RICKENBACKER AIR NATIONAL GUARD BASE
COLUMBUS, OHIO

ADDITIONAL SITE INSPECTION SAMPLING
ADDENDUM #1 TO SI/RI/FS/RD WORK PLAN

FINAL

OCTOBER 1989

FIGURE 2.1

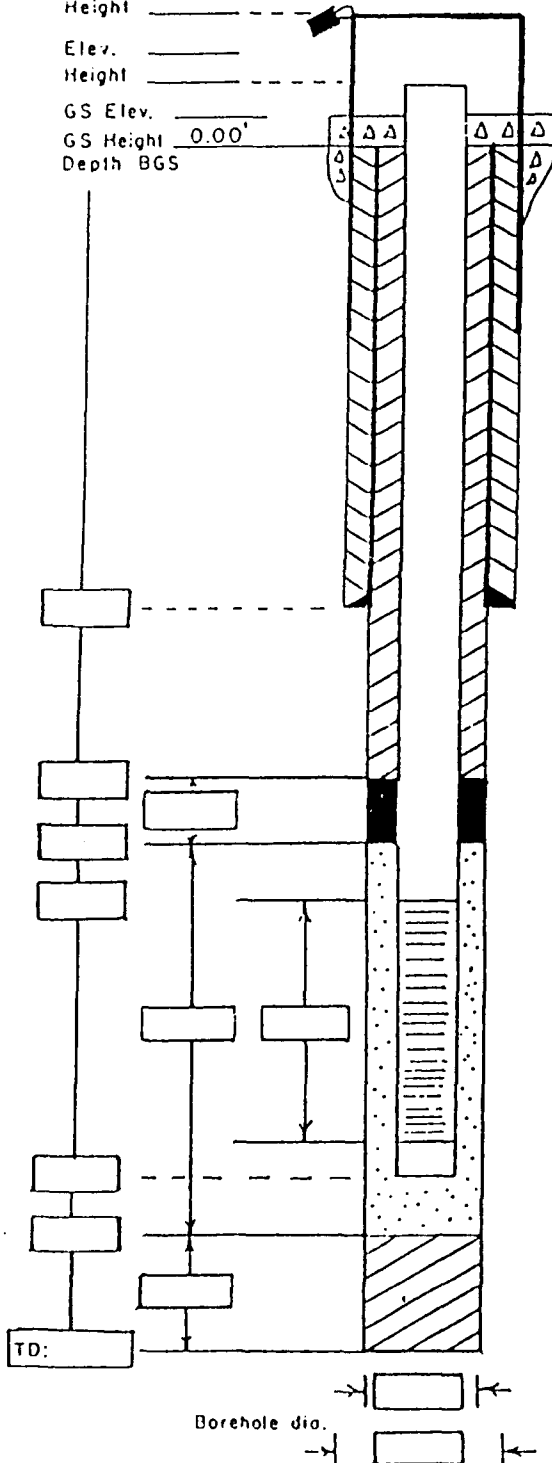
The second modification involves increasing the documentation for monitoring well construction. The HAZWRAP monitoring well construction log shown as Figure 2.1 will now be used in all reports.
